City of Round Rock

Planning and Zoning Commission

Meeting Agenda - Final

Wednesday, April 19, 2017

**The Depot Townhomes Phase 1
FINAL PLAT FP1703-002**

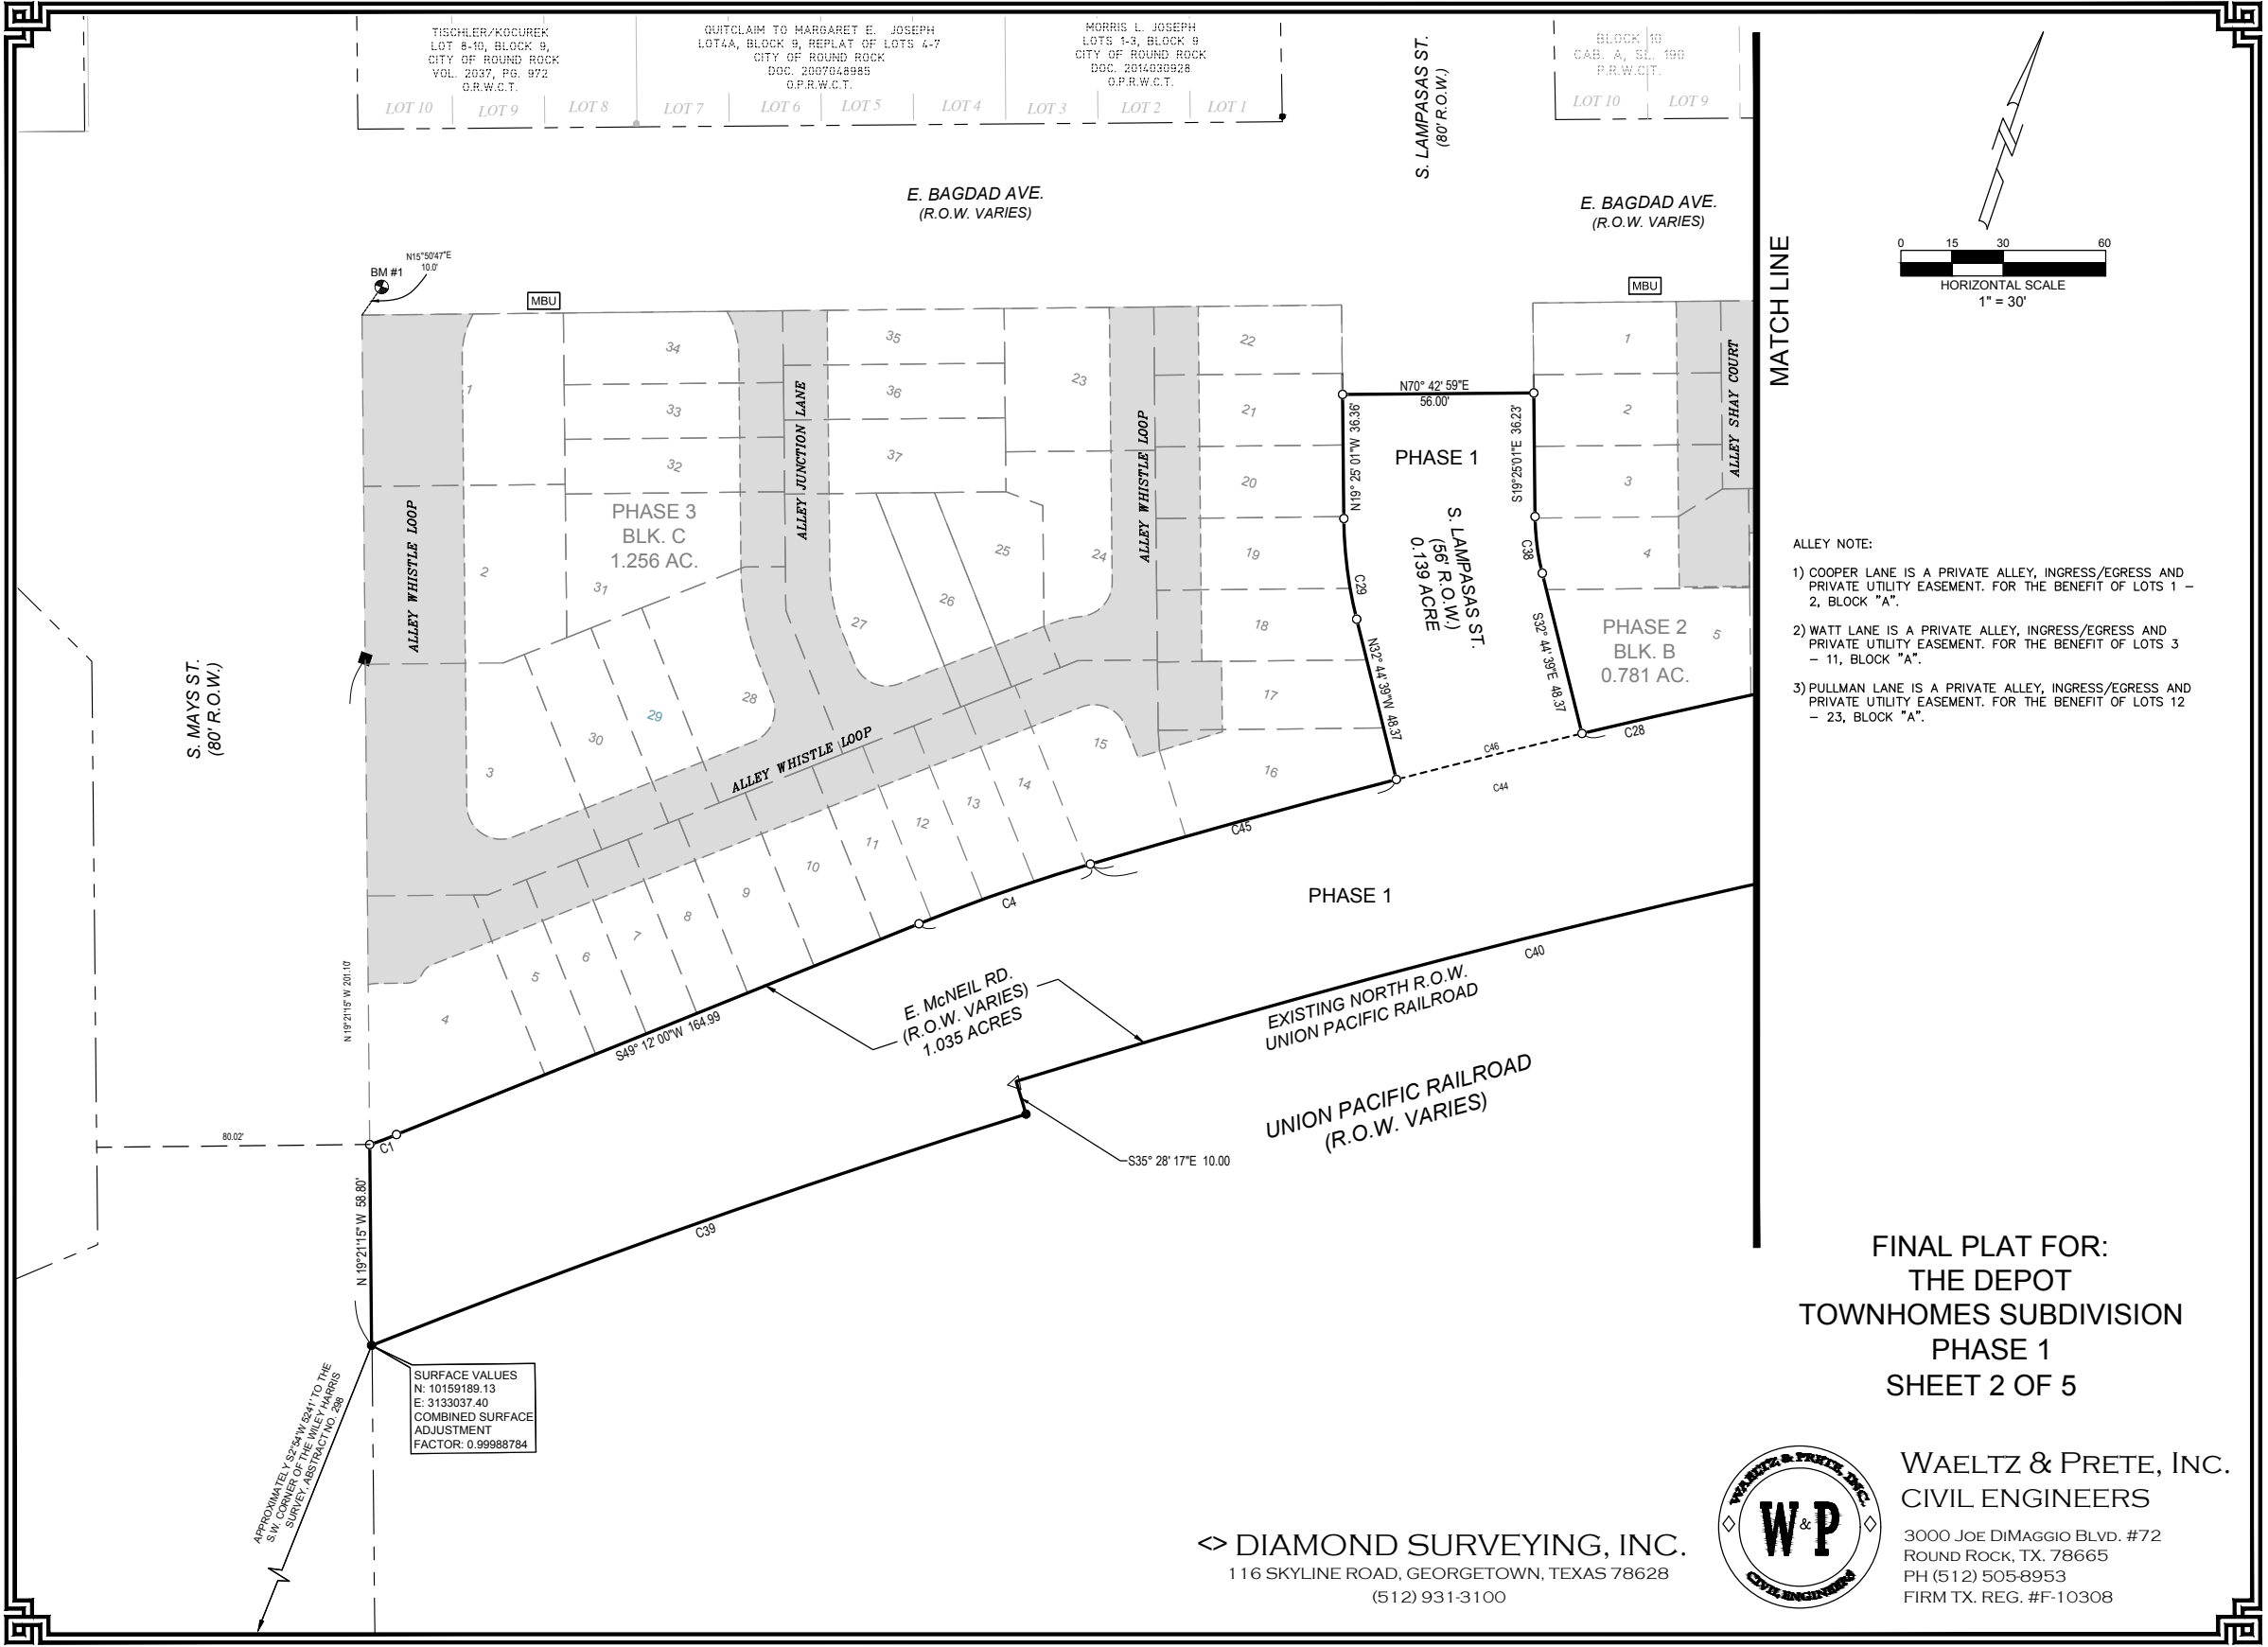
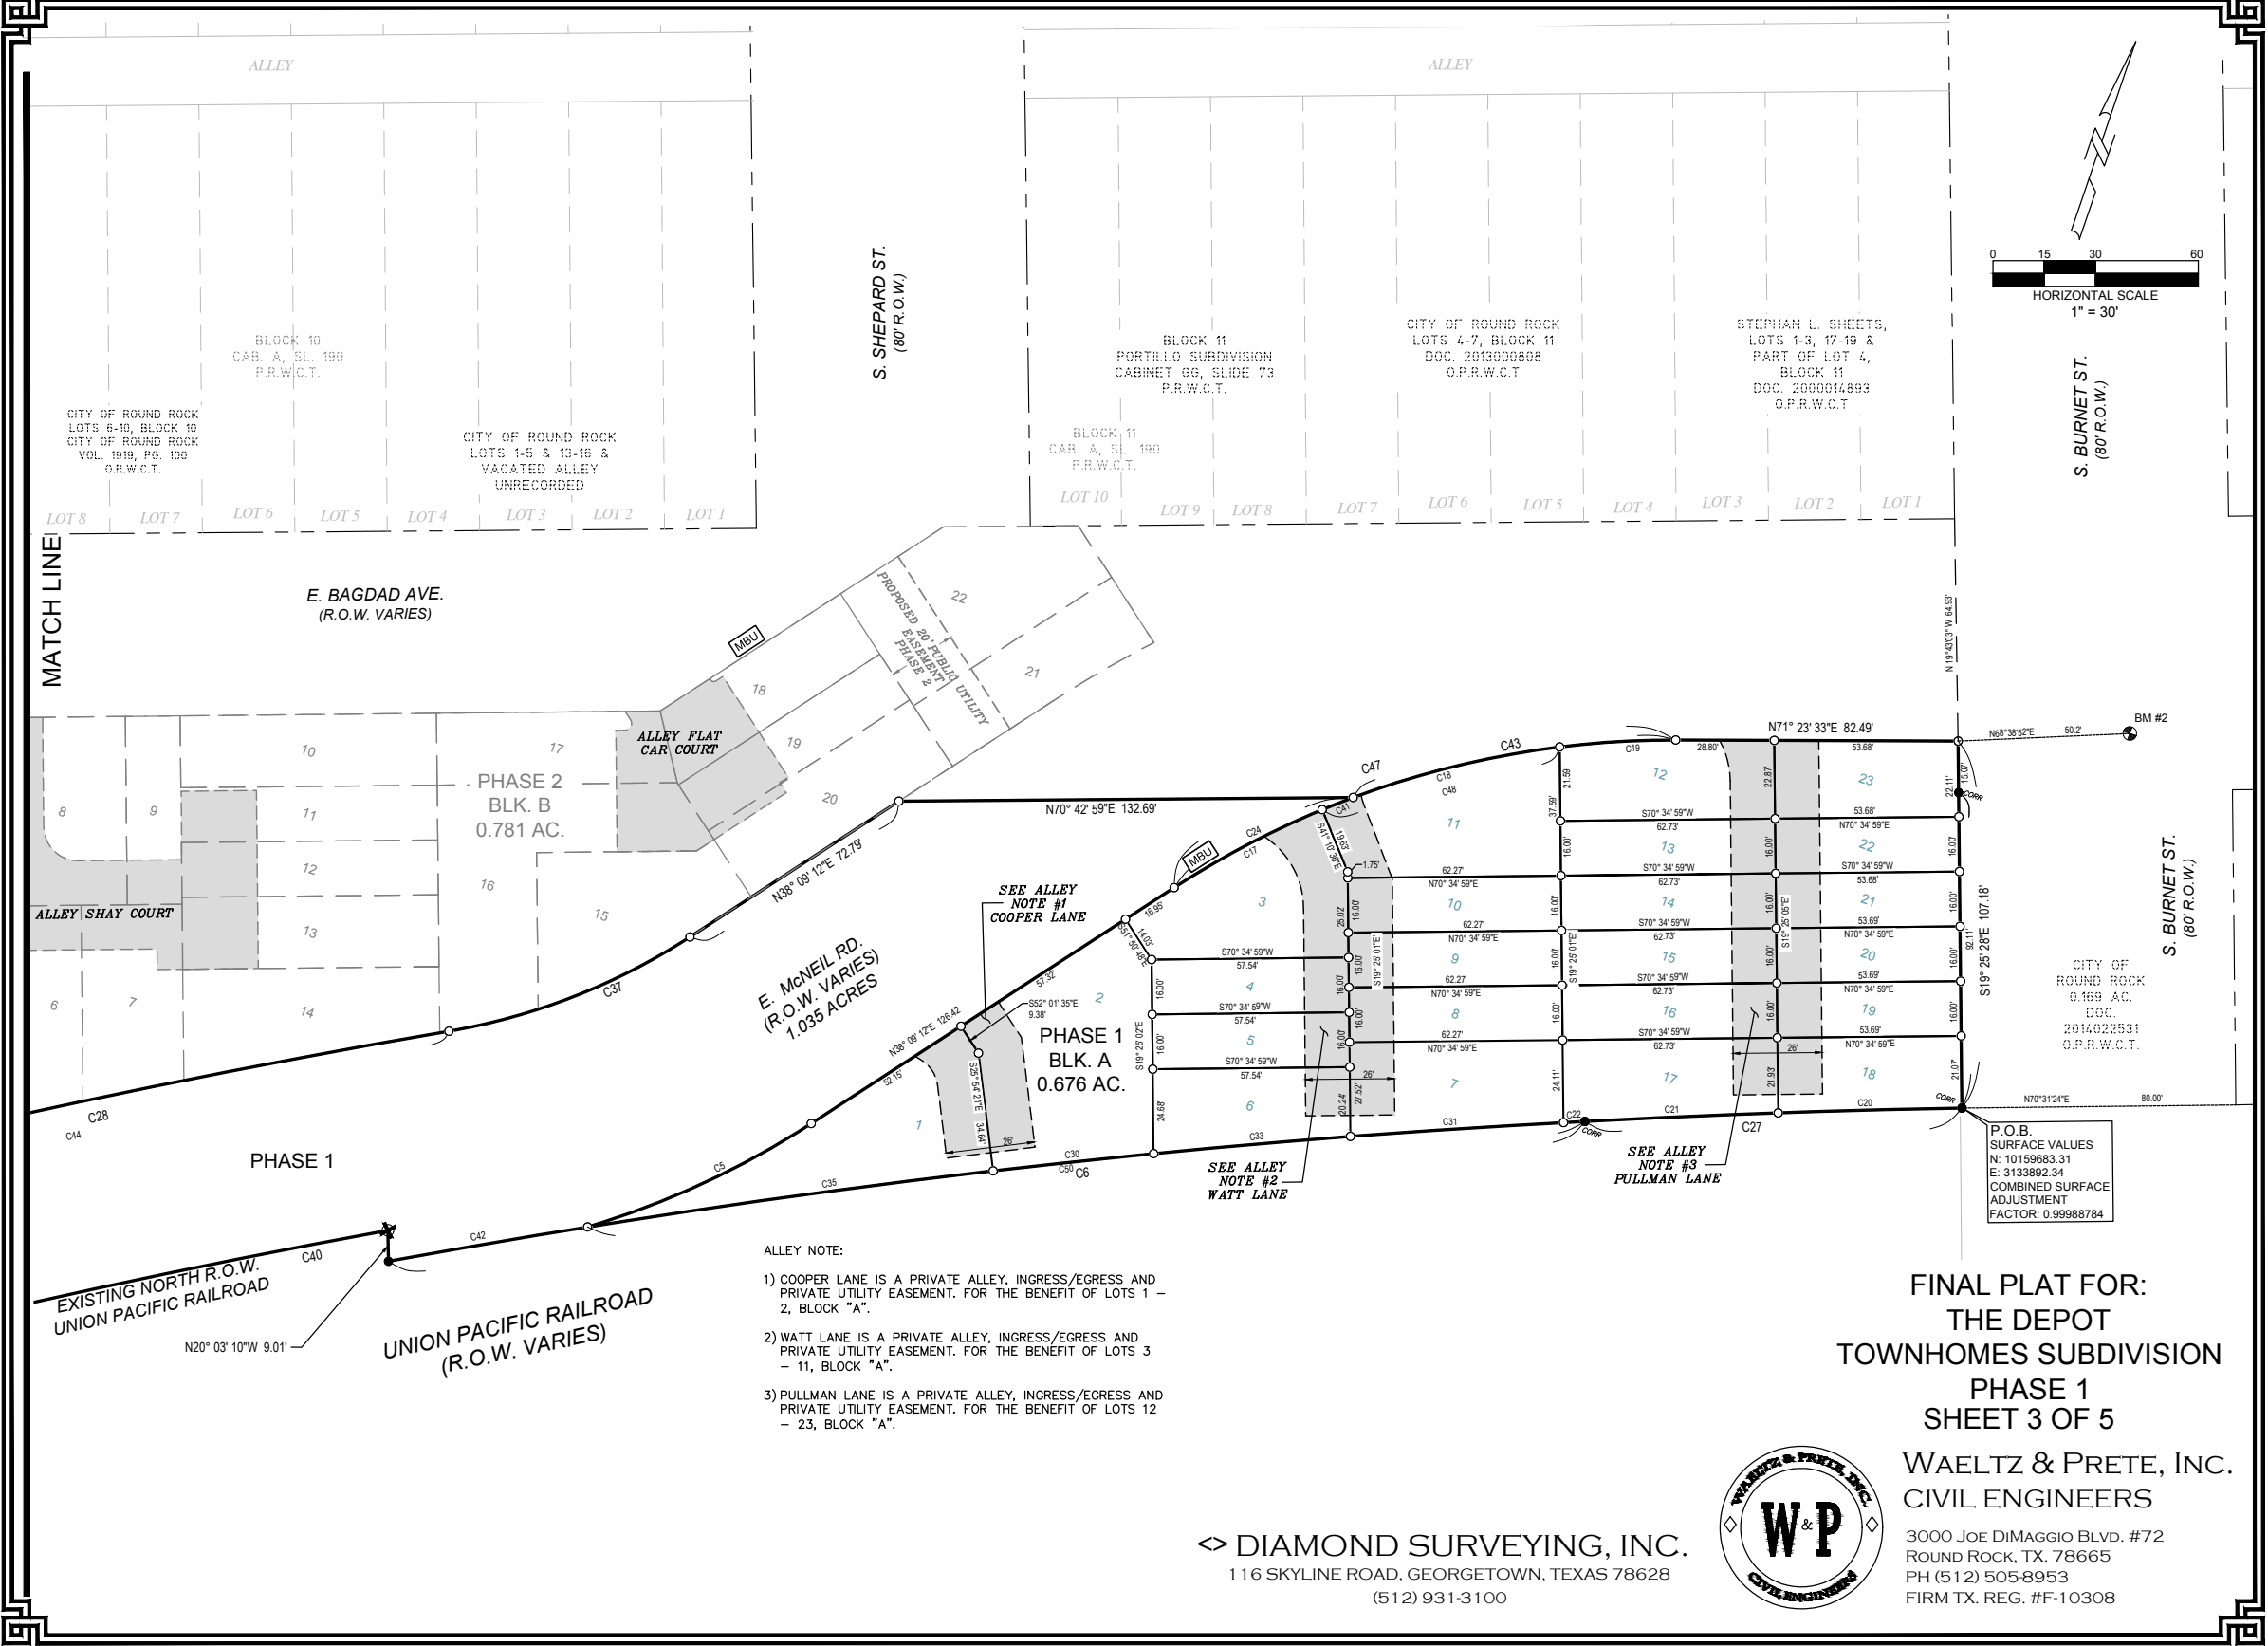
1. Approval is contingent upon City Council approval of PUD 110.
2. Fill in all PUD and document numbers left blank in current submittal.
3. Change note #3 to the following: This final plat conforms with the preliminary plat as approved by the Planning and Zoning Commission on April 19, 2017.
4. Change Note # 4 to the following: No unit shall take direct driveway access to any public right-of-way.
5. Prior to or in tandem with final plat recordation, an Ingress and Egress Easement to the City to traverse alley areas shall be recorded.
6. Change the suffixes of Pullman Lane, Watt Lane and Cooper Lane to reflect streets' cul-de-sac designs. Correct alley notes to reflect the suffix changes.
7. Move the word "alley" away from the internal alley names to avoid confusion that "alley" is part of the alleys' names.

FINAL PLAT FOR:
THE DEPOT
TOWNHOMES SUBDIVISION
PHASE 2
SHEET 3 OF 4

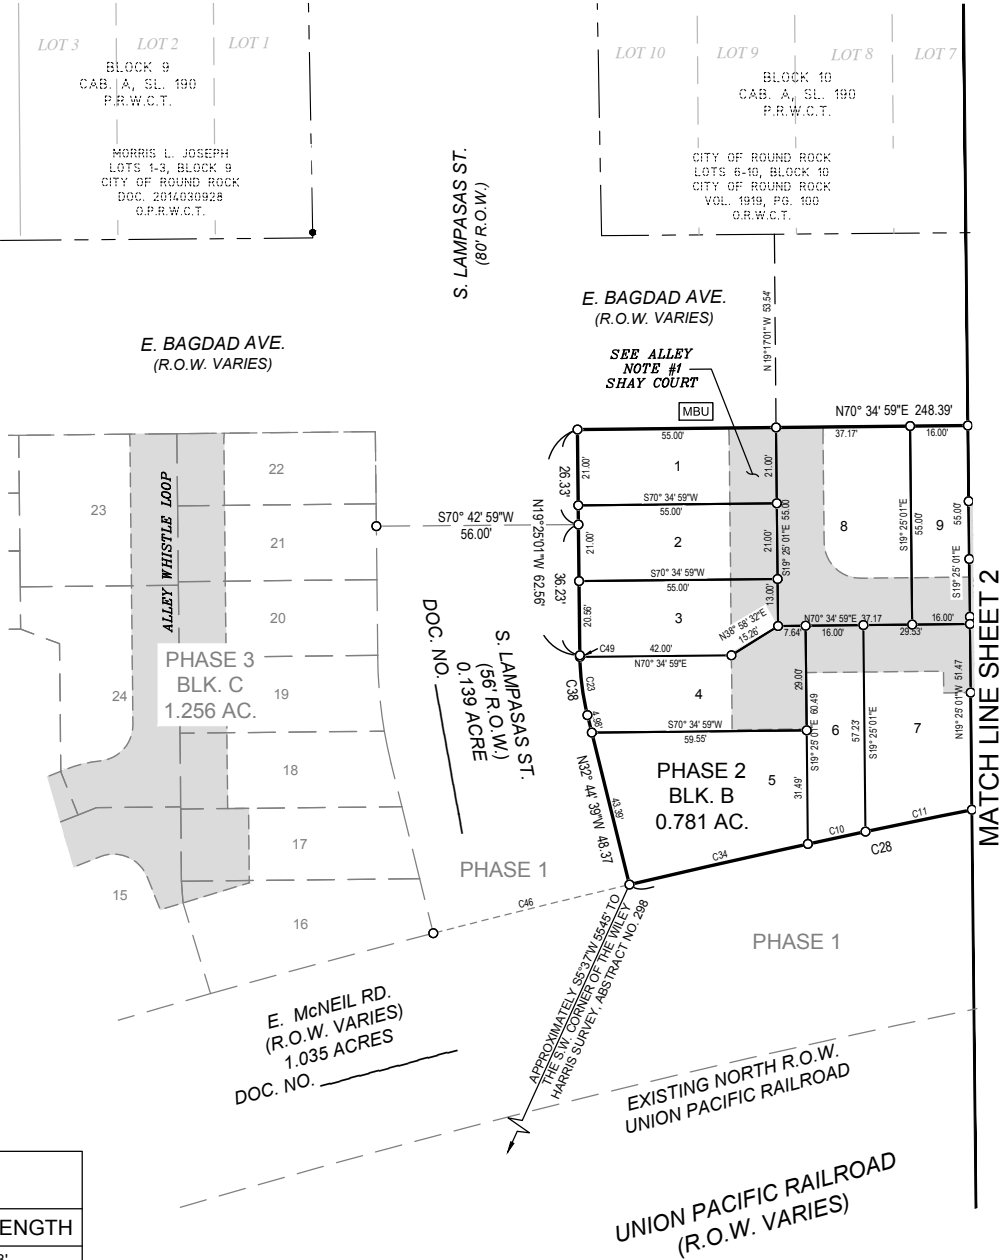
1. Please re-center plat to make all of phase 2 fit on a single sheet.
2. Fill in all PUD and document numbers left blank in current submittal.
3. Approval contingent upon City Council approval of PUD 110.
4. Change Note #3 to the following: This final plat conforms to the preliminary plat as approved by the Planning and Zoning Commission on April 19, 2017.
5. Change Note # 4 to the following: Except for Lots 21 and 22, Block B, no unit shall take direct driveway access to any public right-of-way.
6. Prior to or in tandem with final plat recordation, an Ingress and Egress Easement to the City to traverse alley areas shall be recorded.
7. Please change alley labeling to make clear the "alley" is not part of each alley's name.
